38-11 ELEV "A"

CONSTRUCTION SUMMARY

Grovetrail Developments Inc.

LOT NUMBER	PHASE	HOUSE TYPE	CLOSING DATE
30	1	BELVEDERE Elev A	31-Oct-22

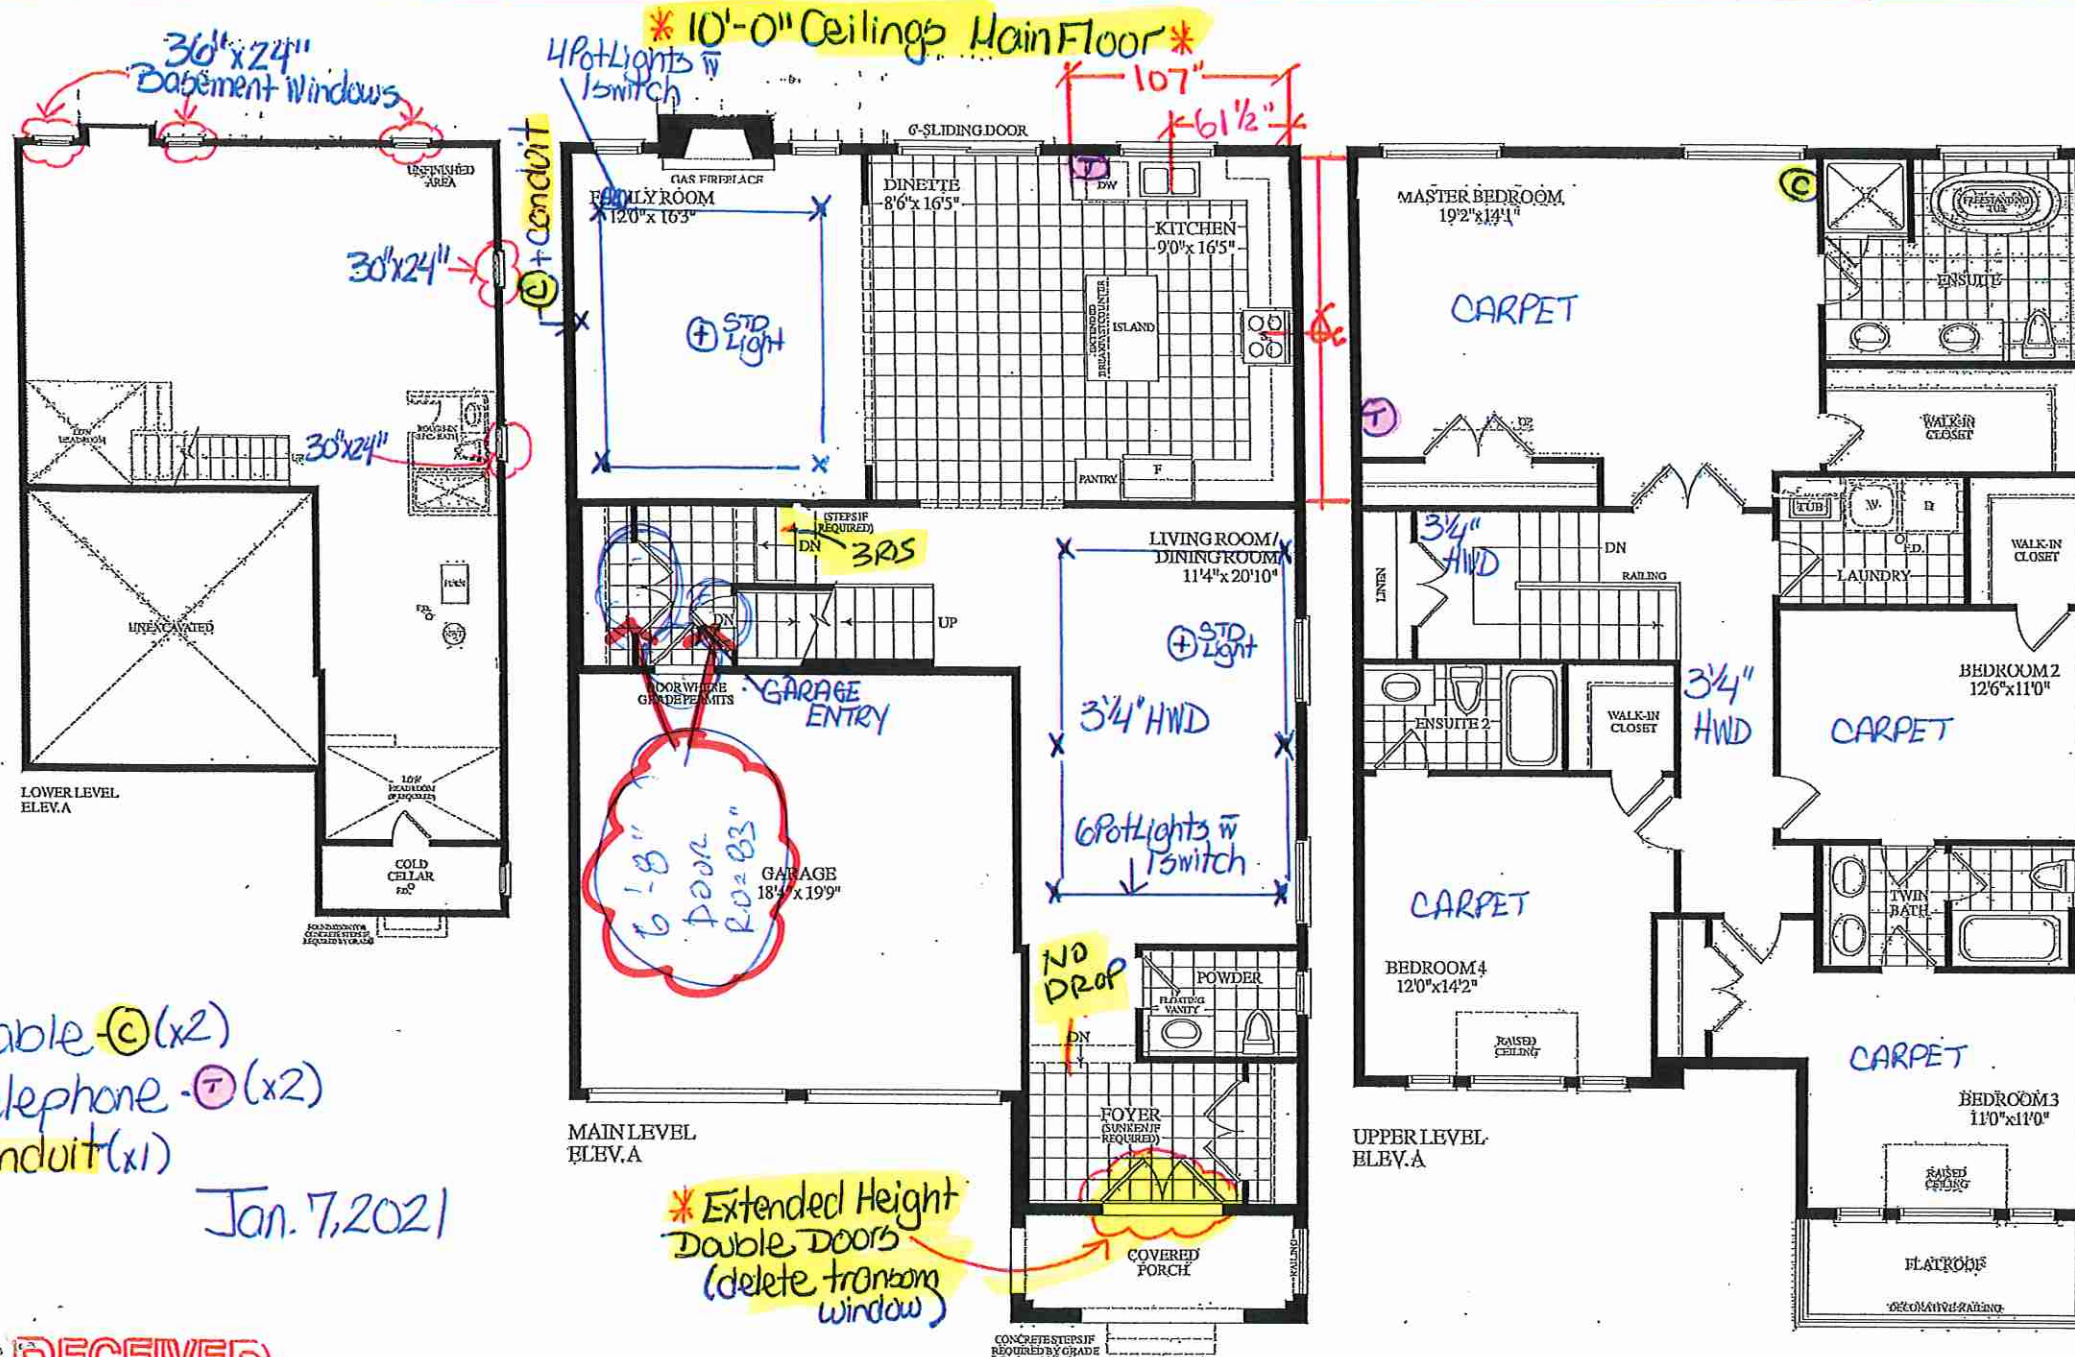
* 10' CEILING MAIN FLOOR

* Extended Height
Double Doors
(delete transom
window)

MAIN FLOOR - INTERIOR DOORS - Interior Doors at Garage Entry (Double Door Closet and Door Leading to Basement) (x3 Doors) To Remain Standard Height (6'-8" Door R.O 83") as per Fonzie (See Sketch)

1 - FRONT EXTERIOR - FRONT DOORS - Install EXTENDED HEIGHT DOUBLE FRONT DOORS (Delete Transom Window Above) in lieu of standard height double front doors (See Sketch)
Note:

1 - MAIN FLOOR - Install EXTENDED HEIGHT 10'-0" CEILINGS throughout Main Floor, To Include; 8'-0" Interior Doors (Door Height Approx. 92") (Standard Door Only) and Taller Windows, where applicable (See Sketch)
Note:
